**Minutes of the Meeting
February 5th, 1998**

Projects Reviewed

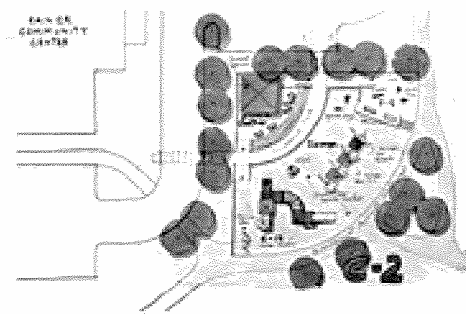
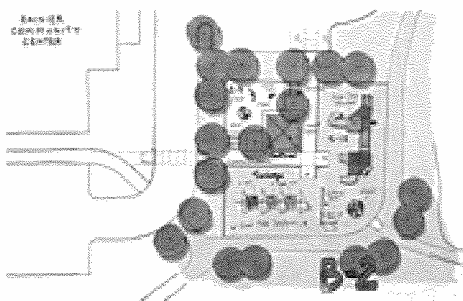
- Batra:** Why the lack of public response?

- Kordik:** I'm not sure. We were surprised, since the same amount of mailings and advertising was used as on other projects.
- Darwish:** Are parts of the play structure replaceable in case of damage or future expansion?

- Darwish:** Are you replacing the swings?
- Gold:** Yes. They will be new ten foot high swings, three bays with two swings in each bay. They are also designed to include three seat types for various ages.

- Batra:** Are there any benches for adults watching children play?
- Gold:** There are two existing benches that will probably be renovated or replaced.

- Swift:** I agree that bench seating for adults is important around the site. Have you looked at the five year old population and how they might use the play area?

- Gold:** They are totally modular systems. Given the existing site limitations, future expansion of the play structure is unlikely. The structures are primarily steel with an electrostatically applied vinyl finish and are very durable. They are very few plastic pieces in the system.

- Gold:** We have tried to design for multiple age populations through a progression from a two to five year old area at one end to a five year and older area at the other end.

West Elevation

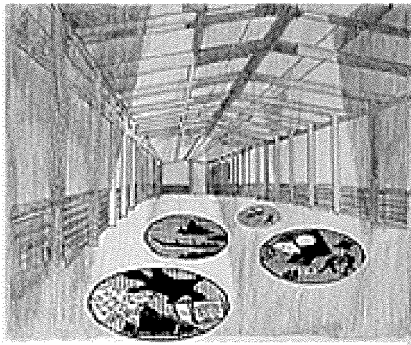
- Darwish:** What would a person see from outside of the bridge at night?
- Murakami:** The bridge would have a significant night presence and one would see a rhythm of light pools across the bridge.
- Batra:** Given the stair width, is a central railing required?
- Murakami:** Yes. We would like to add more landings but are trapped between two property lines and don't have the necessary distance.
- Swift:** Many landings can be equally annoying. I like having the greater number of steps

- Foley:** The elevator tower mass is emphasized by not having a masonry bridge structure.
- Sundberg:** What happens to the bridge roof within the tower mass?

- Sundberg:** The stairs appear to be what the bridge is landing on. I am not totally convinced about the roof sliding into the tower as apposed to butting against it. The west elevation is nice, but the east elevation seems a little chunky.

- Swift:** I agree that you should look at the intersection of the roof and the tower, and at the way the bridge lands on the stairs.
- Action:** **The Commission recommends approval of the project as presented in design development. The Commission strongly supports the active involvement of the artists. The Commission recommends more study and further**

- Murakami:** The overhangs are removed as the roof goes behind the U-shaped elevator parapet wall.
- Darwish:** Will there be art on the bridge support columns?

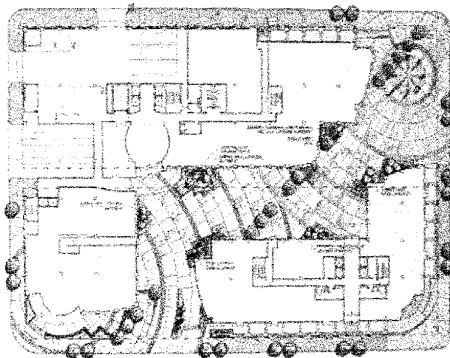
Swift: I like the warmer tones on the facade. In the event of budget constraints, could you leave the tile on the existing building.

Foley: I think that the new facade is nice and respects the existing building. The termination of the arched awning over the entry doors seems unresolved and problematic.

Layzer: Could the two entrances be reduced to one?

Lokan: Probably not. We will need to replace the cast iron front for structural reasons.

Lokan: We had a single entry in the center, but the restaurant tenant requires two exits.
